Case File / Name: ASR-0091-2022 DSLC - DS ENTERTAINMENT VENUE

CONDITIONS OF APPROVAL and NEXT STEPS:

ENTERTAINMENT VENUE DOWNTOWN SOUTH - LOT 17 ADMINISTRATIVE SITE REVIEW 130 PENMARC DRIVE RALEIGH, NORTH CAROLINA, 27603

C2.00

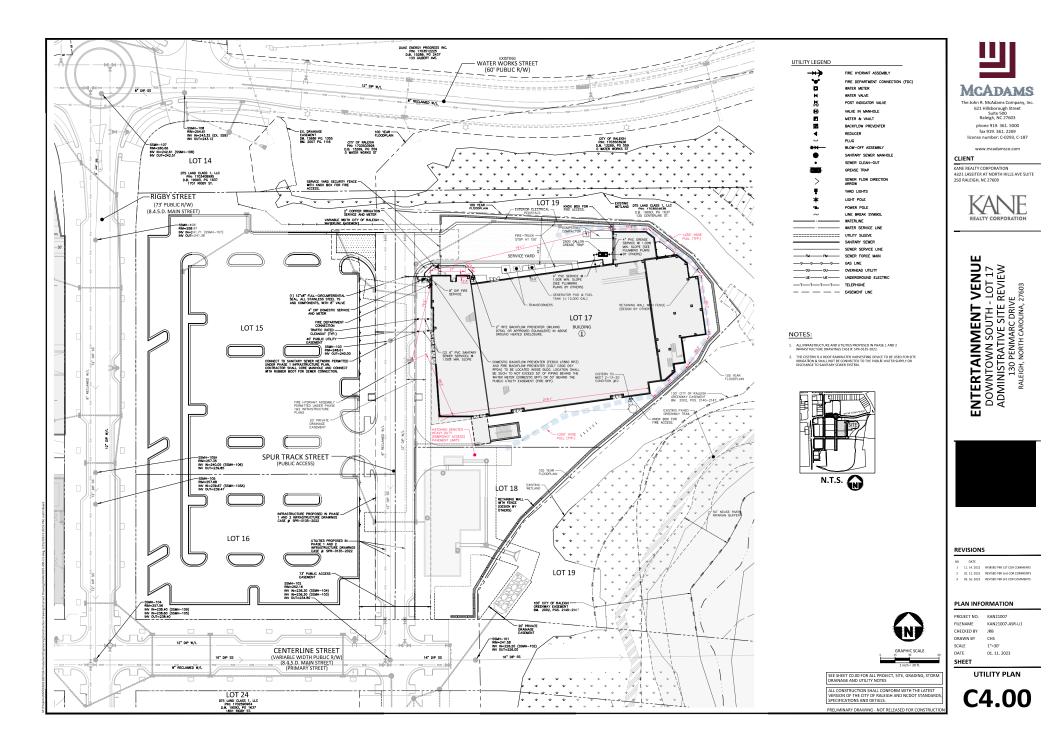
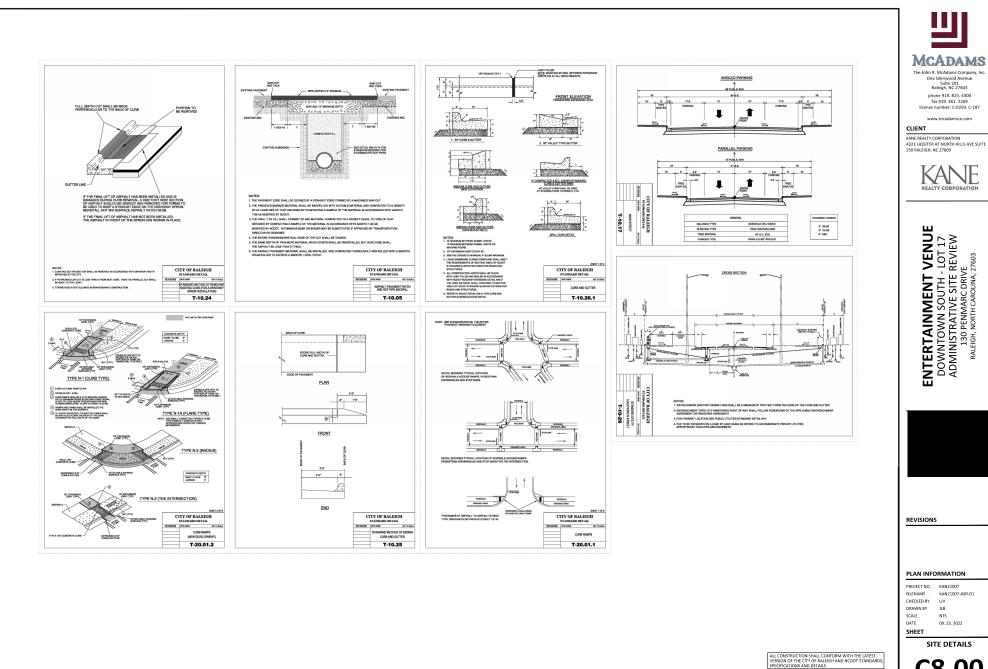
- See sheet C2.01 Clarify "overhead landing stair access" demonstrating compliance to 0-6' side lot building setback. What is this specifically, and how does it comply with 0'-6' side lot line building setback (3.2.5 B and 1.5.4 D)-MW
- 2. Provide existing square footage charts demonstrating compliance to conditions number 8 and condition number 9 of Zoning condition Z-13-20. (see sheet C0.01)
- 3. Correct gross building square footage on cover sheet application as sheet C3.01 shows a building to be 35,500 square feet and application on cover sheet notes 75,400 square feet. Correct plan set.
